Office Action Summary	Application No. 10/621,194	Applicant(s) GRIGG, FORD B.	
	Examiner Leonardo Andújar	Art Unit 2826

DETAILED ACTION

Fig. 1

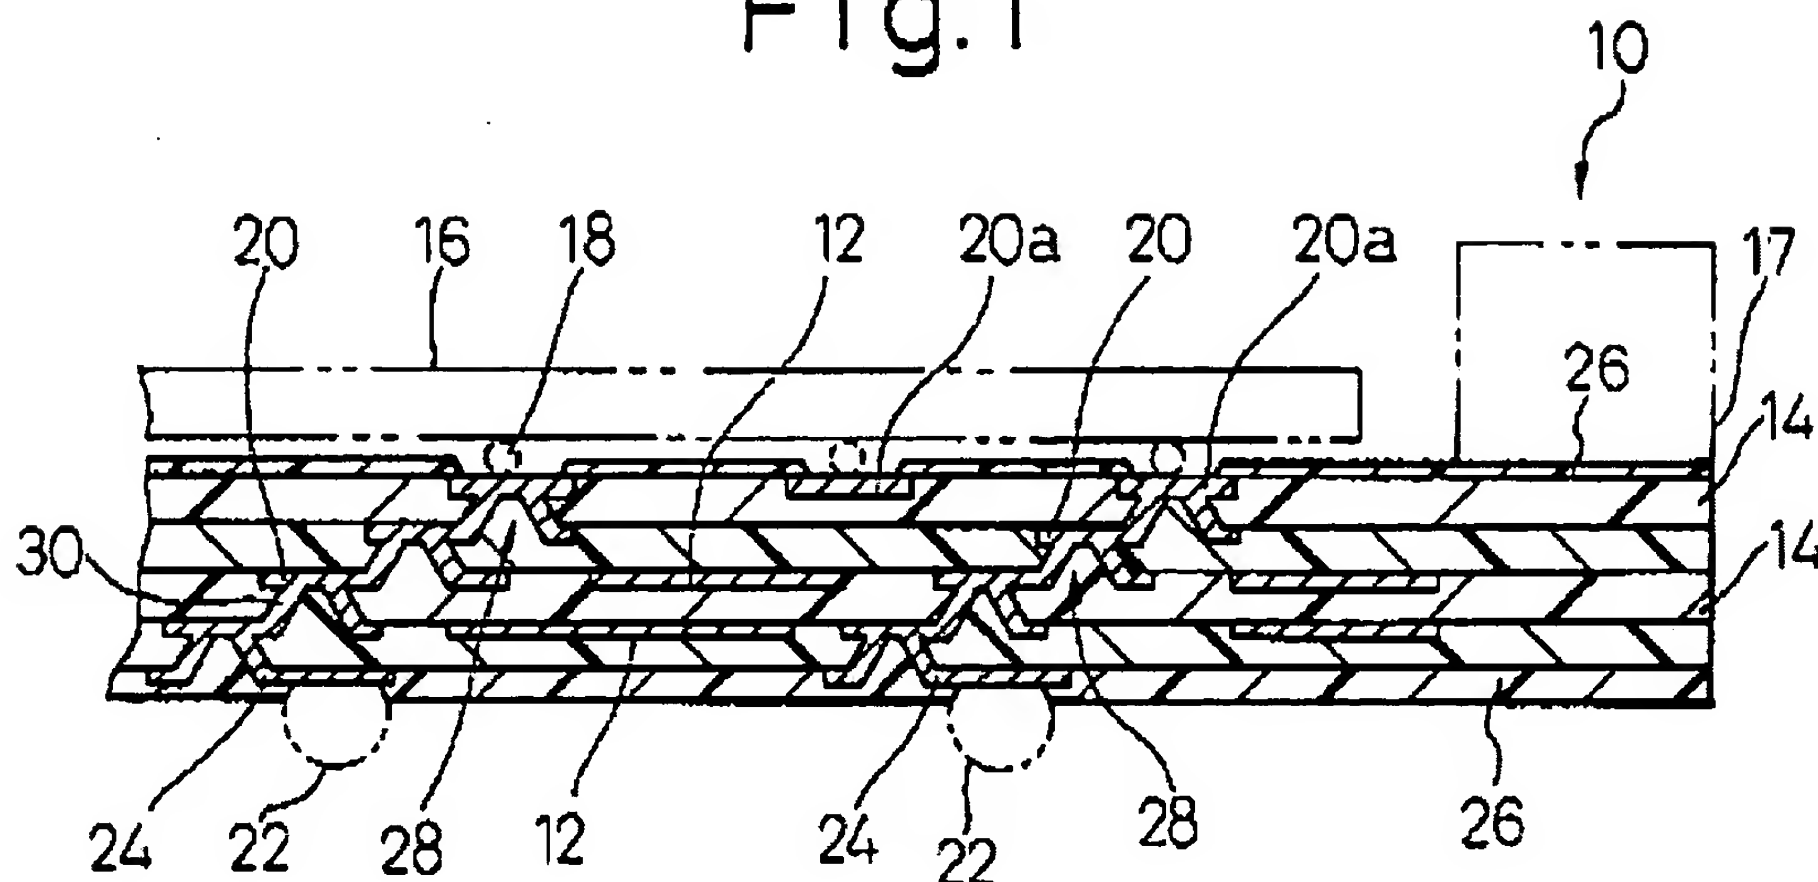
3. Claims 38 and 39 are rejected under 35 U.S.C. 103(a) as being unpatentable over Rokugawa et al. (US 6,418,615) in view of Mizukoshi (US 5,578,525).
4. Regarding claim 38, Rokugawa (e.g. fig. 1) shows a microelectronic die having an integrated circuit 16 and a plurality of bond-pads (the die region contacting the bumps 18) coupled to the integrated circuit; an interposer substrate 14 coupled to the die, the interposer substrate having a plurality of ball-pads 20a electrically coupled to the bond-pads on the die and a solder-mask 26 having openings over the ball-pads; a plurality of solder-balls 18 arranged so that each solder-ball is in an opening in the solder-mask and contacting a corresponding ball-pad. Rokugawa does not show a dielectric compound surrounding a perimeter portion of each of the ball-pads and the solder-balls.

FIG. 4

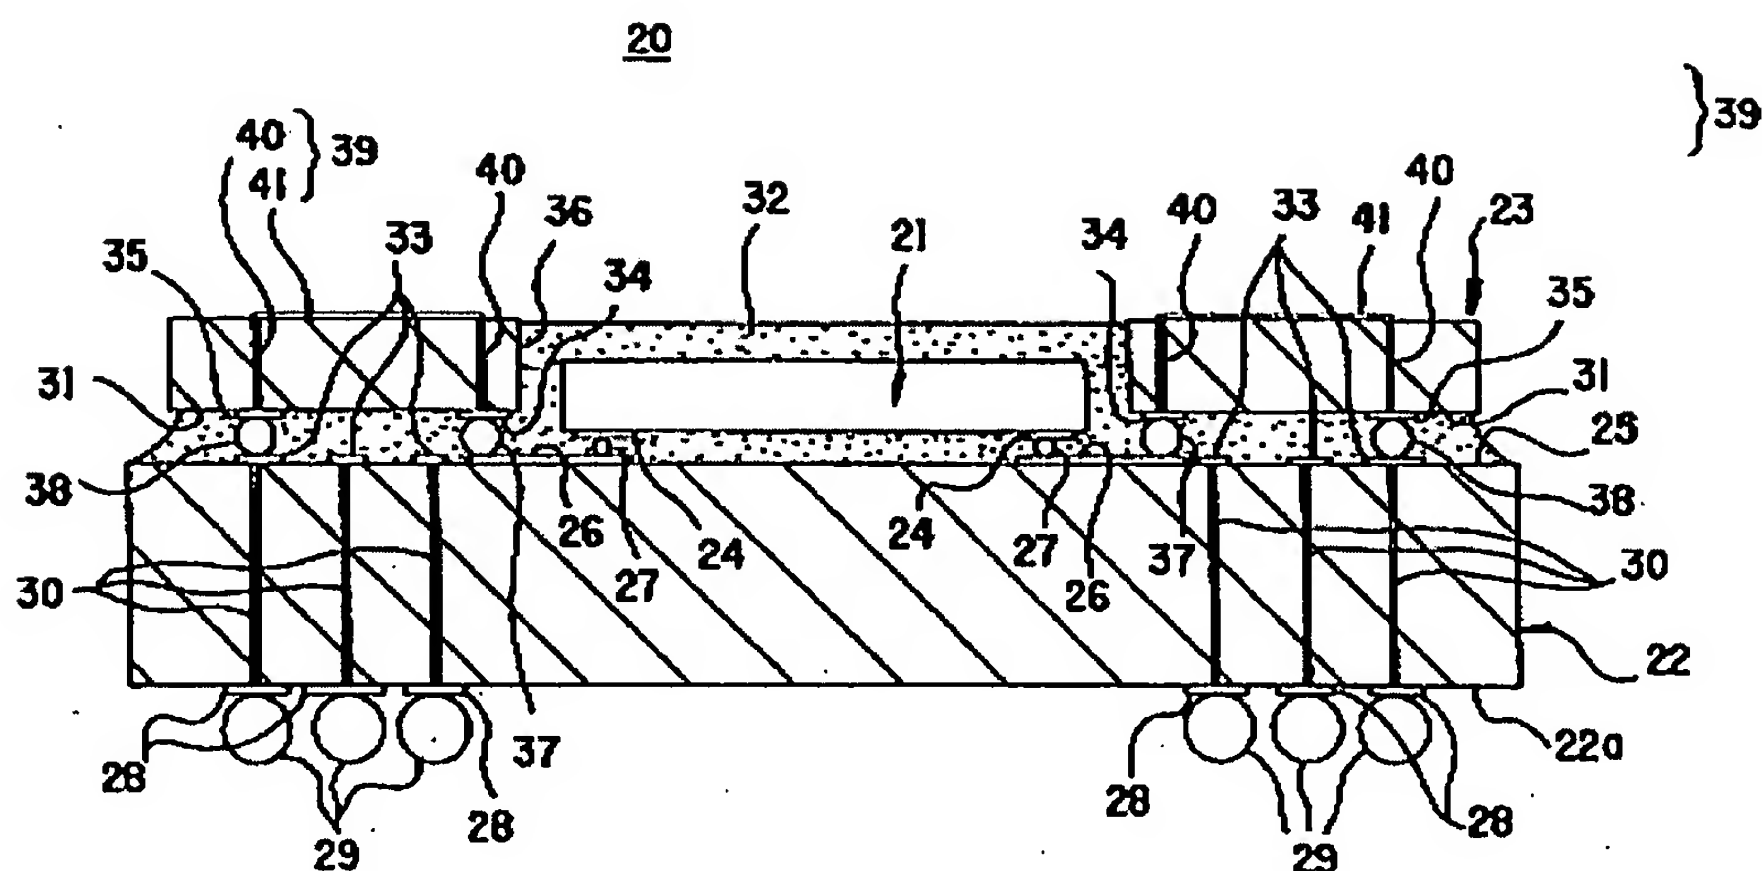
On the other hand, Mizukoshi (e.g. fig. 4) shows a microelectronic die having an integrated circuit 21 and a plurality of bond-pads 24 coupled to the integrated circuit; an interposer substrate 22 coupled to the die, the interposer substrate having a plurality of ball-pads 26 electrically coupled to the bond-pads on the die and; a plurality of solder-balls 27 arranged so that each solder-ball is contacting a corresponding ball-pad. Furthermore, Mizukoshi shows a dielectric compound 32 completely covering the integrated circuit and the interposer's top surface wherein the dielectric compound surrounds a perimeter portion of each of the ball-pads and the solder-balls.

It would have been obvious to one of ordinary skill in the art at the time the invention was made to form a dielectric compound over the IC and over the whole top surface of the interposer disclosed by Rokugawa including the a perimeter portion of each of the ball-pads and the solder-balls as suggested by Mizukoshi to provide a reliable attachment between the chip and the interposer and to provide moisture protection to the IC and to the interposer wiring pattern.
